SERVICE BULLETIN

IGNITION — SHROUD, LEAD PLUG END — INTRODUCTION OF A LONGER
SHROUD TO IMPROVE COOLING

V2500 Series 70-1005

74-21-43

LOCATION OF SHROUD, LEAD PLUG END ON IGNITION LEAD — A
74-21-43-01
FIGURE 1

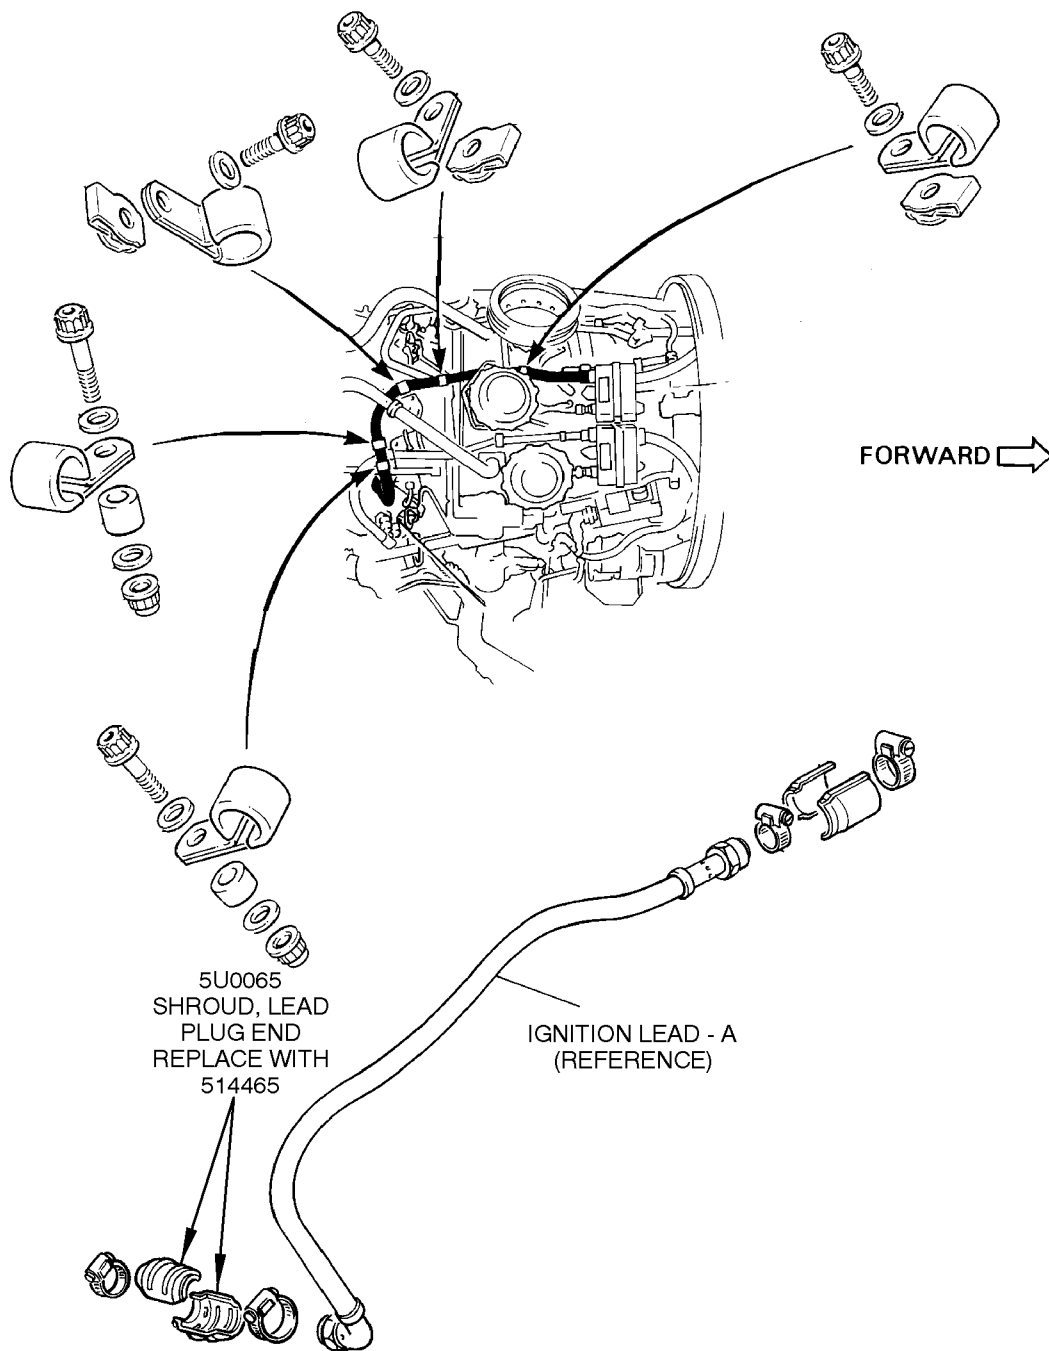
3. Objective: The lack of ignition lead and plug cooling results in reduced reliability and durability. A detailed review of the ignition lead and cooling shroud assembly indicated that 0.177 in (4.50 mm) needed to be added to the stainless steel cooling shroud length to ensure correct alignment with the lead vent holes to ensure sufficient flow of cooling air through the lead and the plug.

Install a new ignition plug cooling shroud to increase length to aid in assembly.

1. For engines installed on aircraft (on wing) do the following procedure. See Figures 1 and 2 for location of parts.
 - A. Replace the Lead Plug End Shroud, PN 5U0065, with a new Shroud, PN 514465, on both leads using the following references based on engine configuration:
 - (1) For V2500-A1 engines, see Reference 9, Aircraft Maintenance Manual, TASK 74-21-43-000-010-A REMOVAL and TASK 74-21-43-400-010-A INSTALLATION.
 - (2) For V2500-A5 engines, see Reference 9, Aircraft Maintenance Manual, TASK 74-21-43-000-010-B REMOVAL and TASK 74-21-43-400-010-B INSTALLATION.
2. For engines removed from aircraft (off wing) do the following procedure. See Figures 1 and 2 for location of parts
 - A. Replace the Lead Plug End Shroud, PN 5U0065, with a new Shroud, PN 514465, on both leads using the following references based on engine configuration:
